**BEFORE THE PUBLIC UTILITY COMMISSION  
OF OREGON  
LC 52**

In the Matter of PACIFICORP  
2011 Integrated Resource Plan

STAFF'S FINAL COMMENTS AND  
RECOMMENDATIONS

### System Capacity with 13 Percent PRM

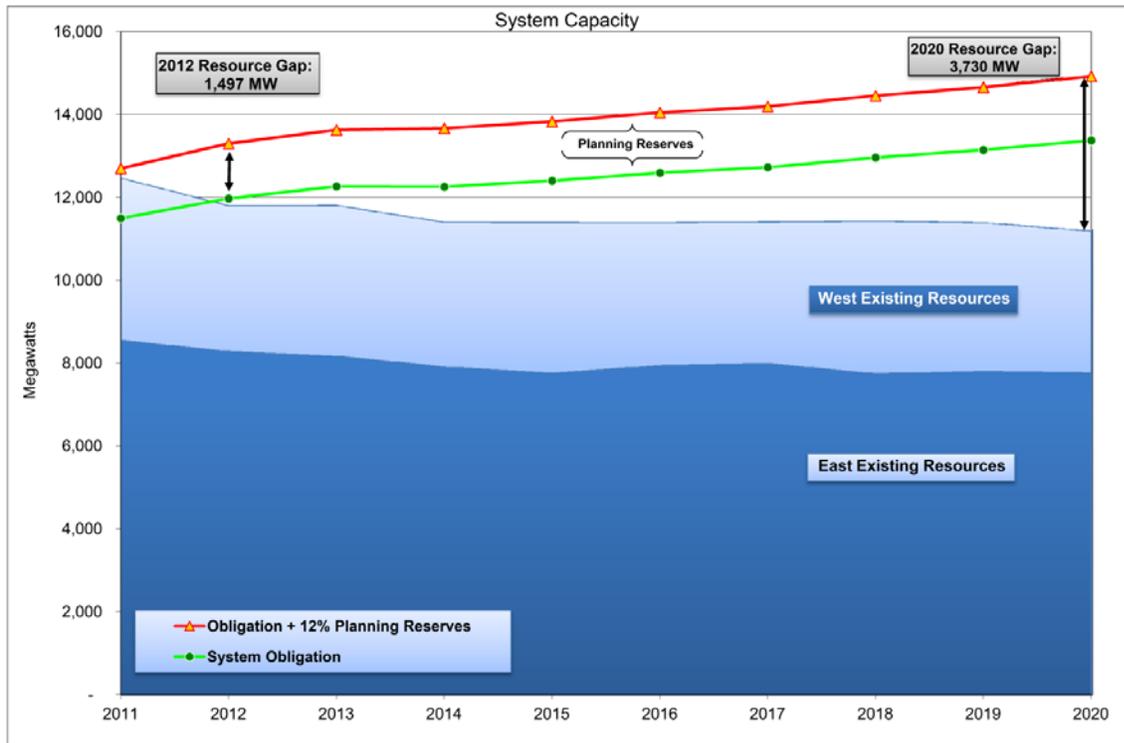
While the marginal costs for a range of PRMs were presented in IRP Appendix J, estimates of the marginal benefits of a 13 percent PRM target were absent. Staff questions the usefulness of the presented marginal cost analysis. In comparing the PVRR of a 12 percent PRM portfolio with the PVRR of a 13 percent PRM portfolio, the incremental PRM values were achieved by adding simple-cycle combustion turbines (SCCTs) to a minimum-PRM portfolio. Staff considers this methodology to be a shortcoming of the risk analysis portion of the IRP. With aggregate loads approaching 15,000 MW in 2020, a one percent increase in PRM translates to more than 100 MW of extra capacity.

Whether PacifiCorp adopts a capacity PRM of 13 percent or maintains the current level of 12 percent is not a major concern on the part of Staff, partly because of the conservative assumptions built into the Company's formulation of its PRM and partly because Staff found no difference in the date when the Company becomes capacity deficient and relatively little difference in the magnitude of the deficiency. Having said this, Staff continues to believe that the contents of IRP Appendix J, which appeared to be the beginnings of a cost-benefit foundation for its PRM determination, was not convincing. Staff found that the costs of achieving the various PRM levels were not based upon portfolios that had been optimized for that purpose and no benefits, in the form of levels of unserved-energy avoidance, were provided. Instead, PacifiCorp used the historic industry standard of adopting a PRM that would be consistent with achieving a cumulative loss-of-load expectation of twenty-four hours in ten years.

PacifiCorp will develop its 2011 IRP Update based on a 12 percent planning reserve margin, unless a different PRM is justified by a marginal cost study comparing costs of portfolios that are optimized for achieving the various PRMs, and including estimates of the marginal benefits from a greater PRM. The study should use loss-of-load hours and unserved energy as the dependent variables.
